Analysis of In-Vessel Retention and Ex-Vessel Fuel Coolant Interaction for AP1000

Energy Research, Inc.

NUREG/CR-6849
ERI/NRC 04-201

Figure 2.1a Schematic of the melt pool configuration I in the lower head (two layers)

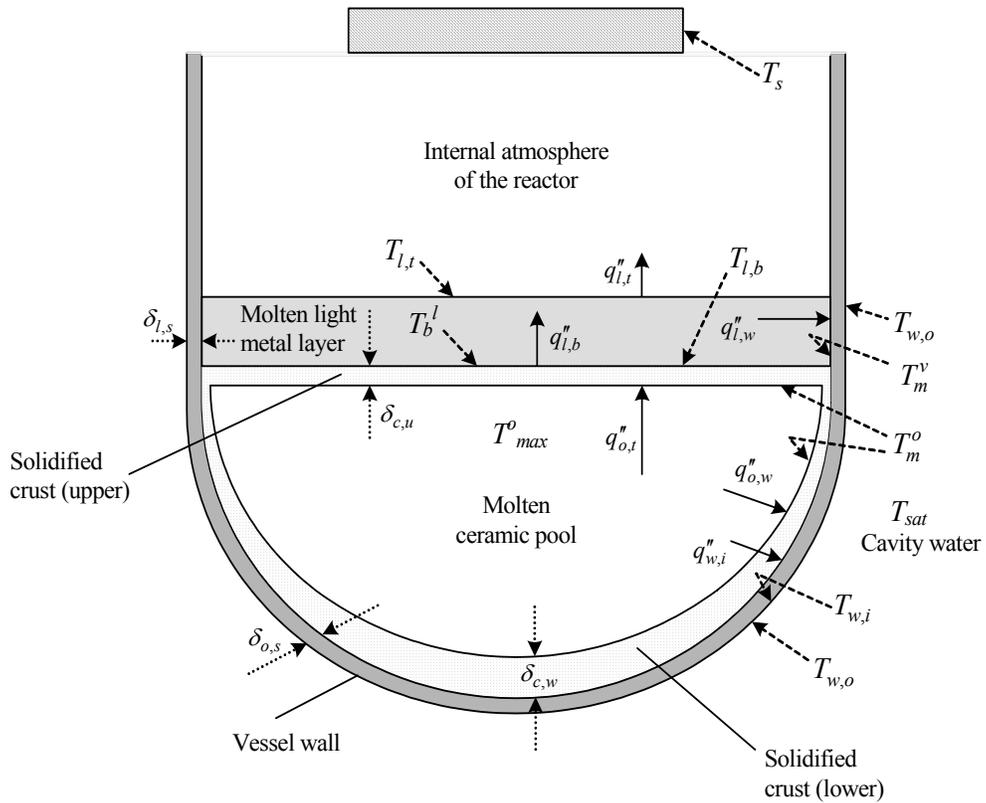
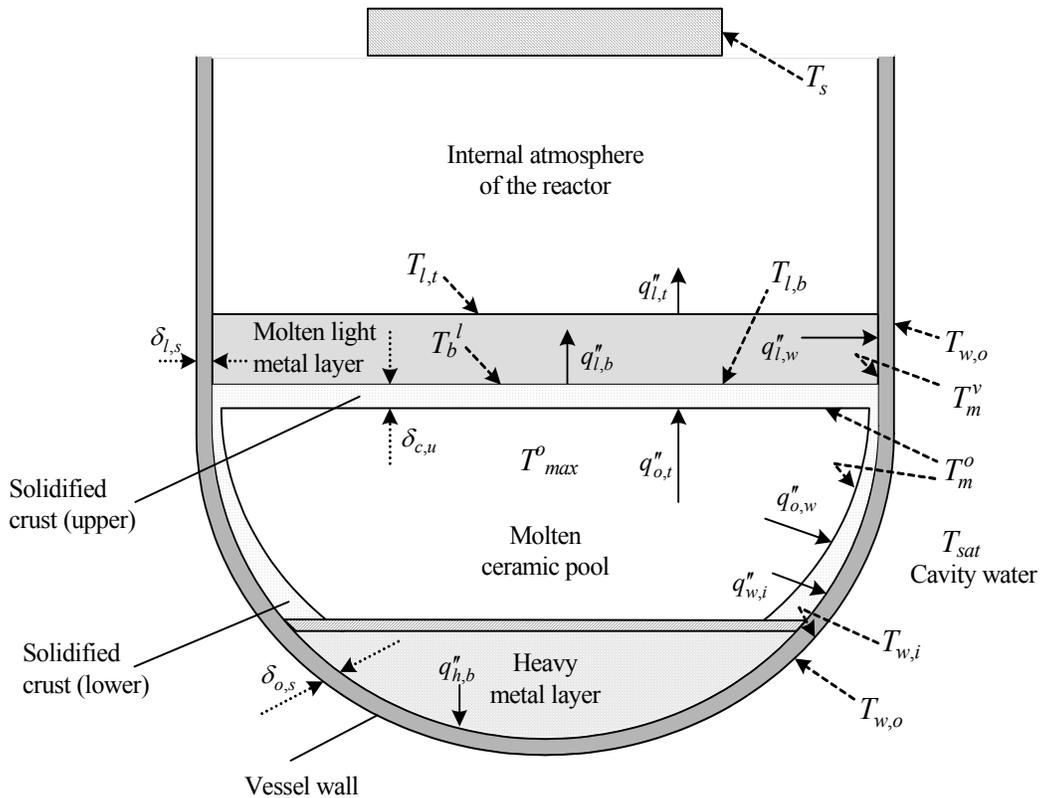
- a. Figure 2.1 shows a crust at the bottom of the light metal layer whereas on the top of page 8 of the report (limitation 2), it is stated that there is no crust.

- a. *The crust shown in Figure 2.1 is the upper ceramic crust which is just below the light metallic layer. The limitation refers to a metal crust in the metallic layer.*

Figure 3.4 Relationship of stainless steel in the lower plenum and the ceramic mass for AP1000

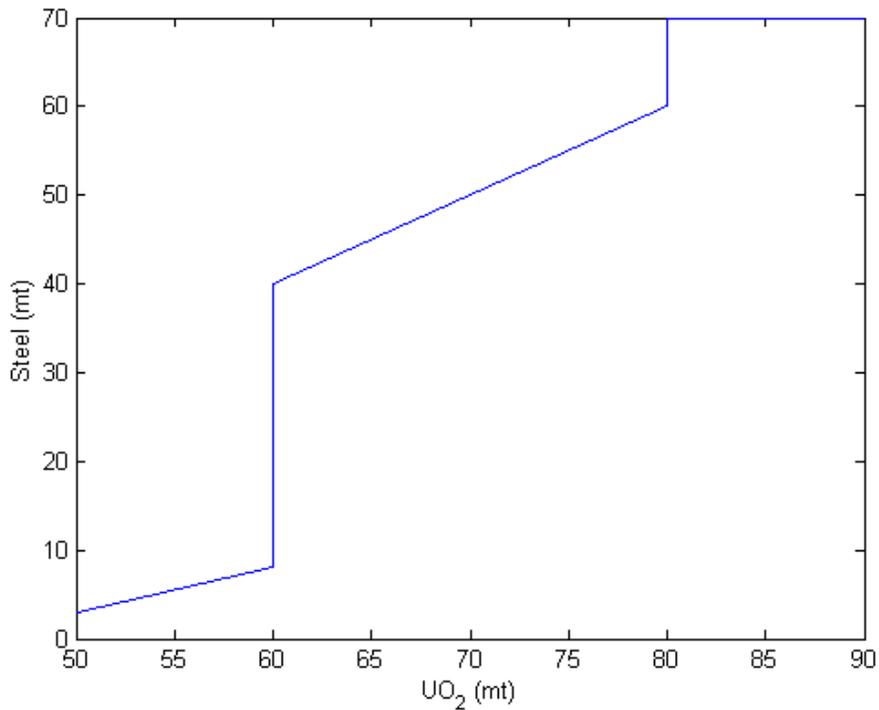
- In equation (3-1), superscripts should be defined.
 - Figure 3-4 shows that amount of stainless steel in the lower plenum increases from 40 to 60 mt when the amount of UO_2 is increased from 60 to 80 mt, but this is not what is stated in the text on page 34.
